Technical Service Information

FORD 4R44E/4R55E/5R55E DELAYED REVERSE ENGAGEMENT

Figure 1

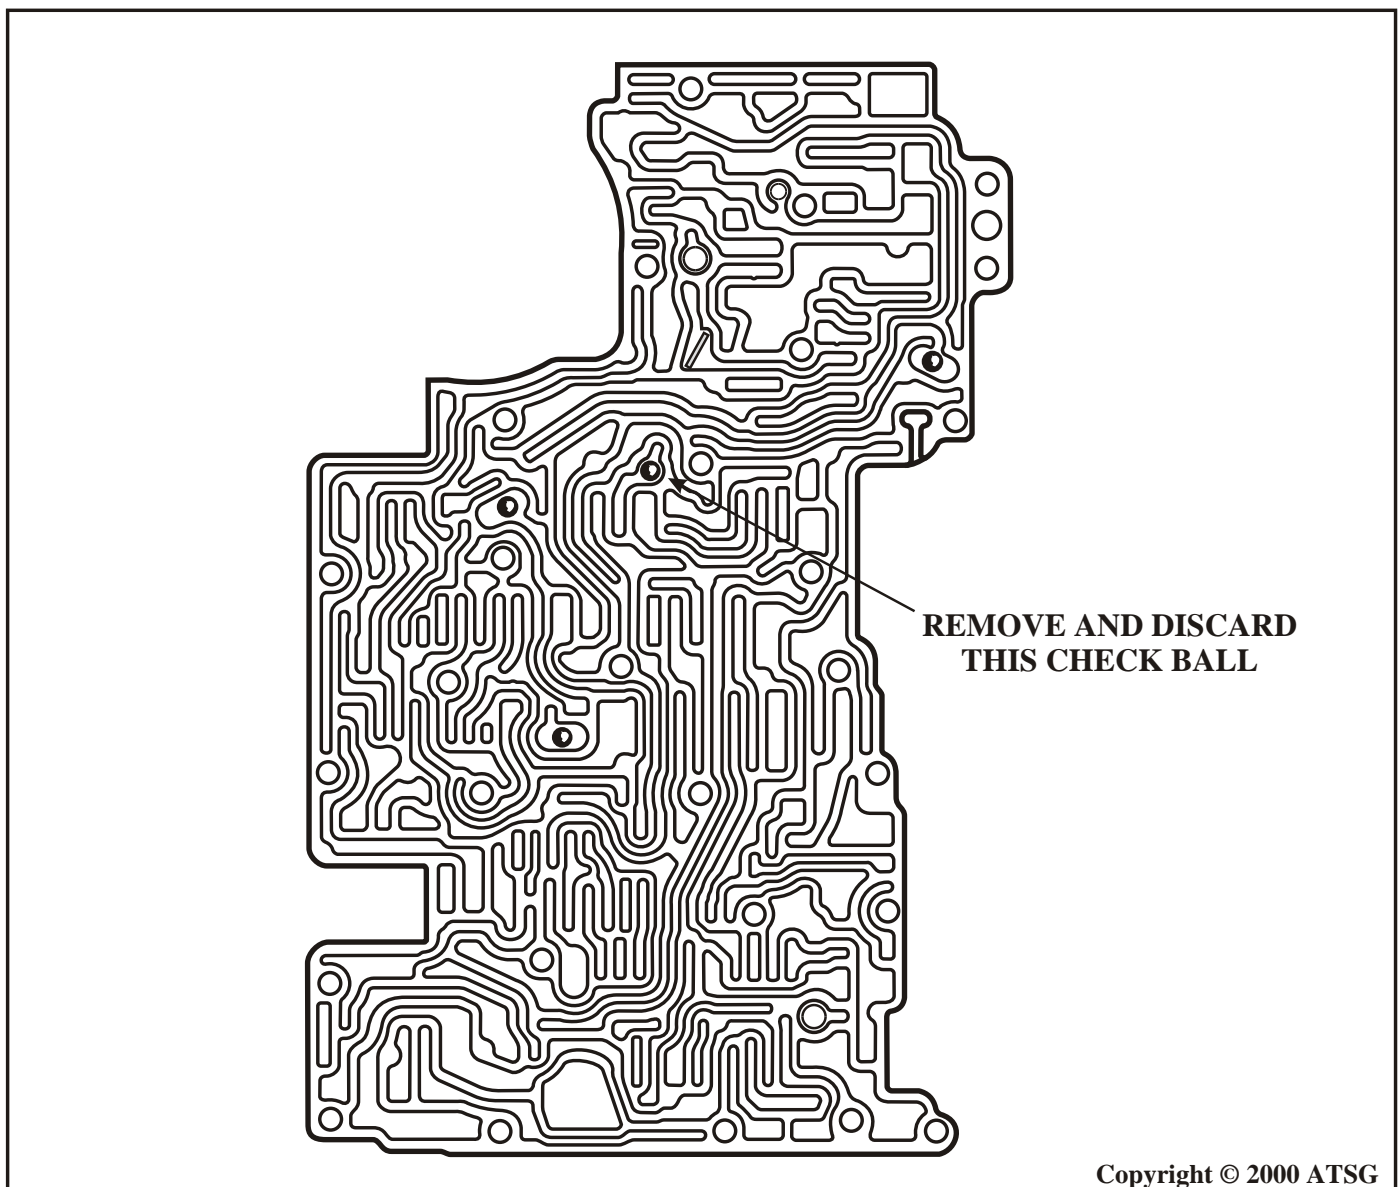
COMPLAINT: Some vehicles equipped with the 4R44E/4R55E may exhibit a delayed engagement in reverse .

CAUSE: One cause may be, insufficient feed to the direct clutch in reverse.

CORRECTION: Remove and discard the check ball as shown in Figure 1.
